# WHITE GARAGE

1915 THIRD AVENUE, SEATTLE, WA 98101  
PROJECT #3037328-LU  
ADMINISTRATIVE DESIGN REVIEW

## Revisions

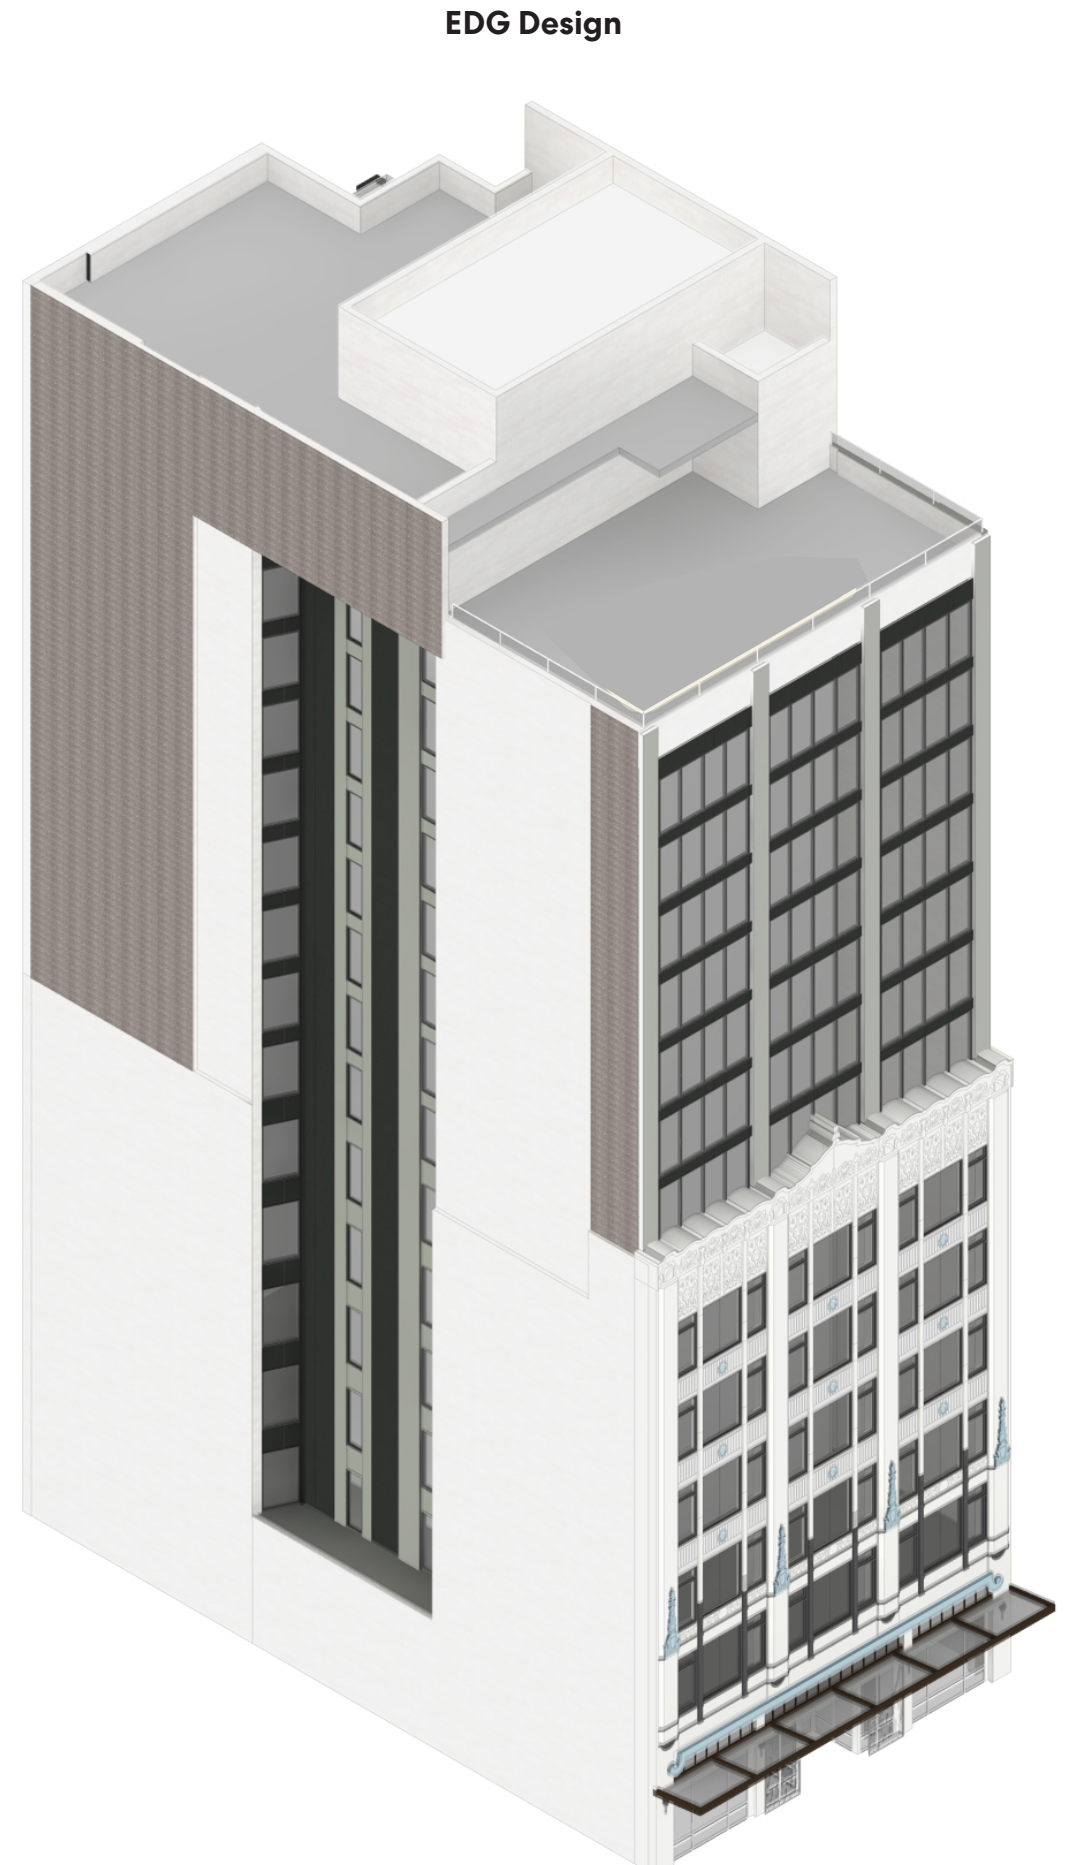
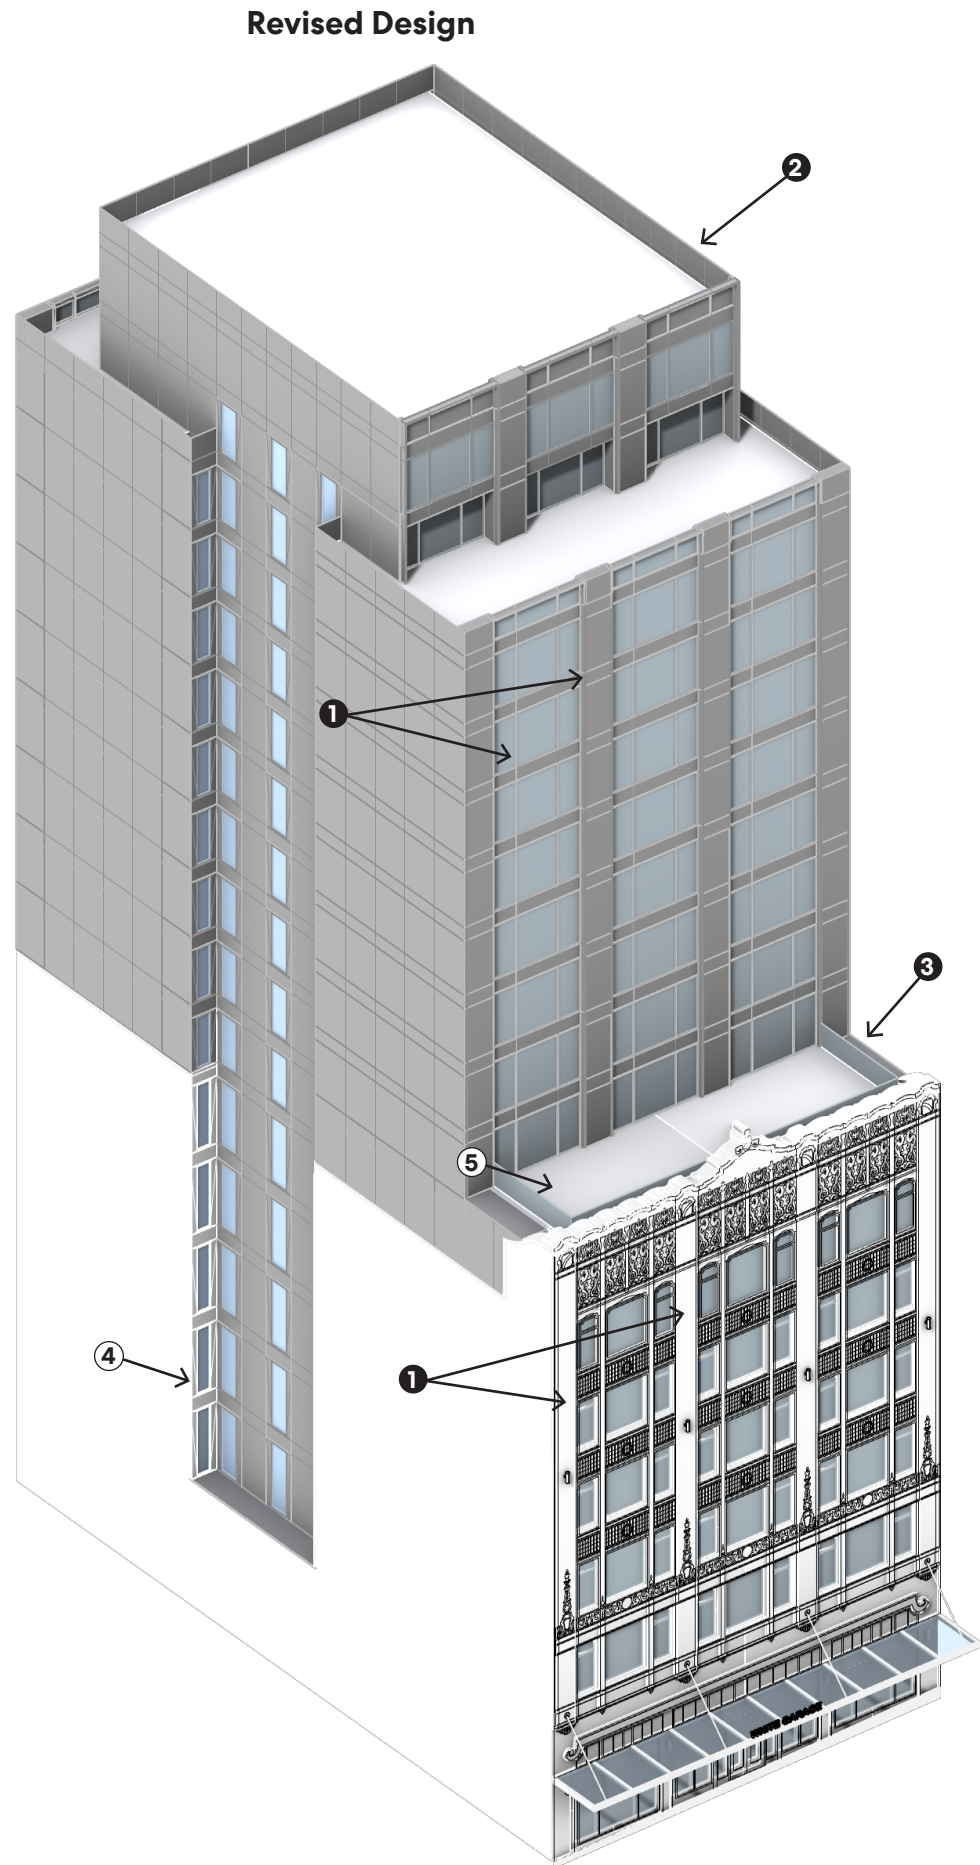
• **SDCI Comment:** EDG guidance 2a-2c discusses the need for a legible architectural expression that establishes a relationship with the Landmark structure below using a compatible structural expression and legibility through detailing and elimination of coplanar materials changes.

The rendering on the first page of the plan set portrays significant depth between windows and framing columns on this facade, which would help to meet this guidance. However, this drawing indicates a minimal amount of depth between the exterior columns and adjacent windows. Please address this issue in the building design. Provide a dimension of this window depth within the Recommendation packet and discussion of how the design addresses EDG guidance.

• **SDCI Comment:** The rooftop screening design appears to show the intent to integrate into the rooftop massing design. However, the attempt to align the rooftop screening panels into the window alignment below does not appear to sufficiently integrate the screening into the overall design. The Recommendation packet should analyze this issue and how the proposed design meets applicable design guidelines. Ideally, the packet will present additional study for roof screening methods (Design Guidelines: A-2 Enhance the Skyline, Belltown A-2. Enhance the Skyline).

• **Response:** The updated expression of the new structure maintains the window bay sizing and vertical facade columns established by the landmark structure.

• **Response:** The revised structure takes a cleaner approach to integrate into the overall massing by maintaining the rigorous window bay sizing and vertical facade columns; key characteristics of the landmark structure.
